REPORT OF THE STANDARDS AND NOMENCLATURE COMMITTEE

FIG. 1.

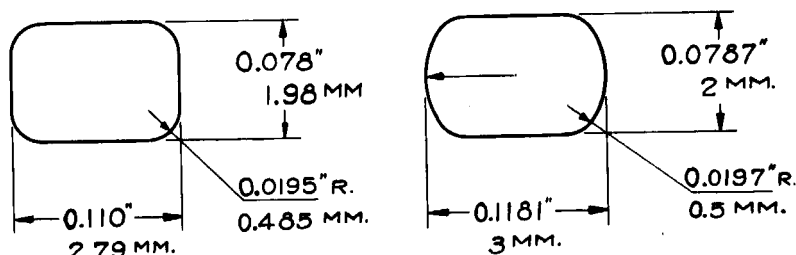
MR. PORTER: Do I understand we are adopting both the "Pathé" and "Kodak"?

PRES. COOK: Yes, and there is no change in the dimensions of those adopted many years ago, the only difference being in the shape of the corners.

CHART A

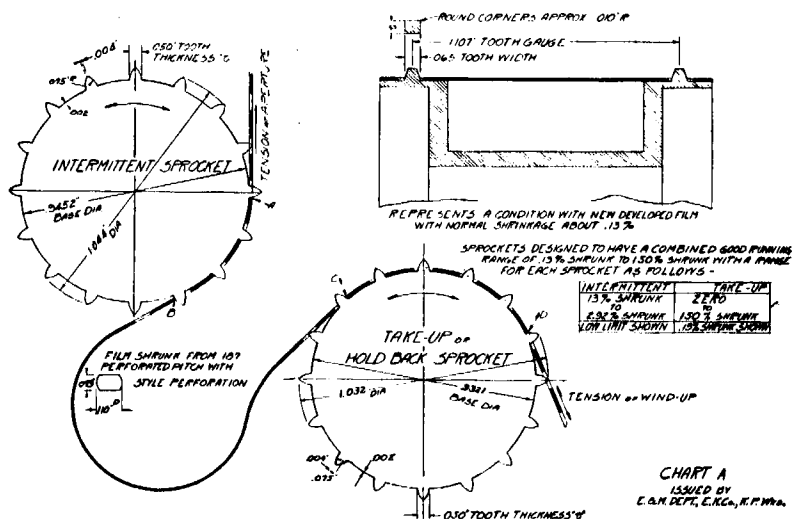
Intermittent sprocket with base diameter of 0.9452 in. (24.01 mm.) has same tooth pitch as the perforations of freshly processed film shrunk 0.13 per cent. Sprocket holes in theoretical contact with four teeth from A to B; i.e., the best running condition is for new film.

Take-up sprocket which is a hold-back sprocket with a base diameter of 0.9321 in. (23.67 mm.) is smaller and the tooth pitch is less than the perforations of newly processed film. There will be a slight clearance at the back of tooth C, also clearance between front of tooth C and all other teeth except the last tooth D which holds the film against the rewind tension. As the film leaves sprocket D, it will slip forward off this tooth until the slight clearance between the sprocket and the next tooth is taken up. If the take-up sprocket is too small the slipping from tooth to tooth is excessive and particularly damaging to new film.

Film shrunk 0.75 per cent representing average film met with in service. Perforation pitch is slightly less than intermittent sprocket tooth pitch. The film is engaged by the last tooth B leaving a slight clearance at the other teeth. As film comes off tooth B, it is engaged by the next tooth. Motion of film is aided by the snubbing action between the film and the base diameter of the sprocket.

Film is held against rewind pull by the last tooth D of the take-up sprocket. There is increased clearance at the back of tooth C, hence no interference at the entering tooth. Compared to new film there is decreased slipping from tooth to tooth due to rewind pull.

Film shrunk 1.5 per cent representing oldest commercially useful film. Intermittent sprocket moves the film by the leaving tooth B. No interference by the back of the entering tooth A occurs until the film is shrunk 2.92 per cent.

Take-up sprocket has same tooth pitch as film perforations; i.e., the theoretically perfect running condition six teeth are engaged. If film is shrunk more than 1.5 per cent interference will occur at the entering tooth C and the sprocket holes will be torn.

The Committee finds that the maximum shrinkage of useful film is 1.5 per cent and recommends a take-up sprocket designed accordingly. The shrinkage of newly processed film for which the feed and intermittent are designed is 0.13 per cent. These latter sprockets as has already been shown will accommodate film shrunk as much as 2.92 per cent without damage. Dimensions of sprockets to produce these results are illustrated in Charts A, B, and C. The essential dimensions are:

CHART IV

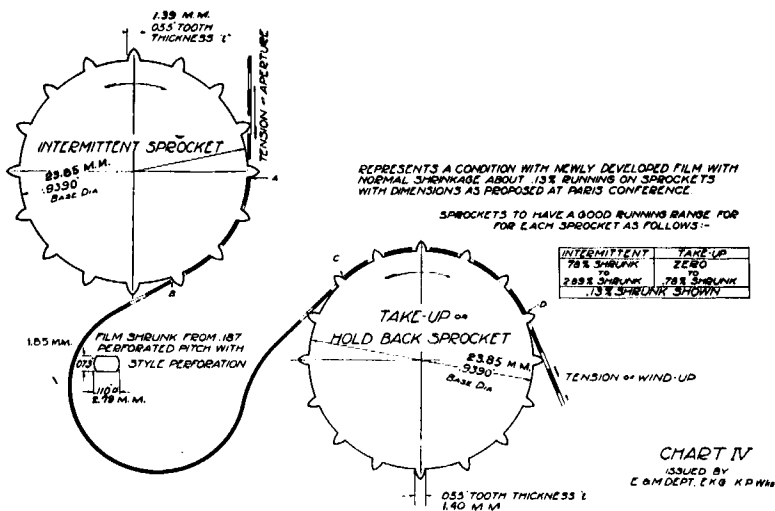
Film is shrunk 0.13 per cent. Entering tooth A of the intermittent sprocket engages the film perforation. When the next tooth engages film it pushes the film forward out of engagement with forward teeth. If tension is too great or film soft as in the case of new film the sprocket hole is likely to tear instead of pushing the film forward. *This condition is to be avoided as it causes damage.*

Take-up sprocket holds film against rewind tension by leaving tooth D and allows clearance to entering tooth C. This condition holds until film is shrunk 0.78 per cent.

CHART V

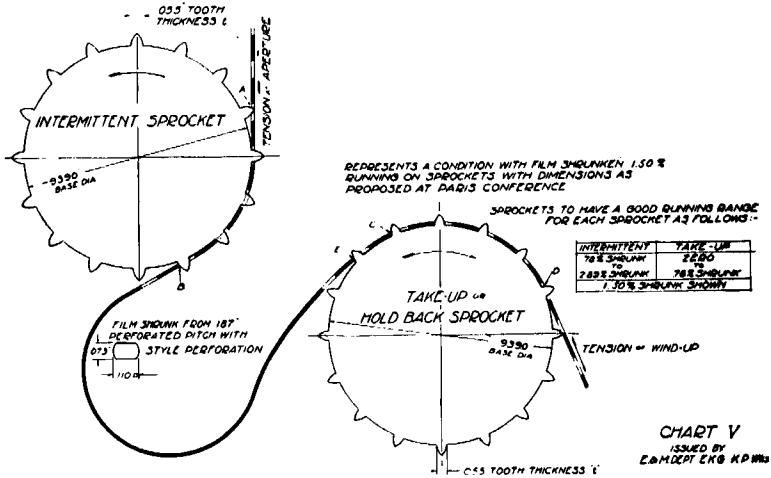
Intermittent sprocket engages film at leaving tooth B leaving clearance at entering tooth A. This good running condition occurs at 0.78 per cent shrinkage and holds until film has shrunk 2.89 per cent.

Take-up sprocket engages film at entering tooth C. When next tooth E engages film, either (1) film is pushed forward, (2) film climbs sprocket tooth or (3) perforation is torn. This condition occurs at 0.78 per cent shrinkage and is more aggravated the greater the shrinkage.
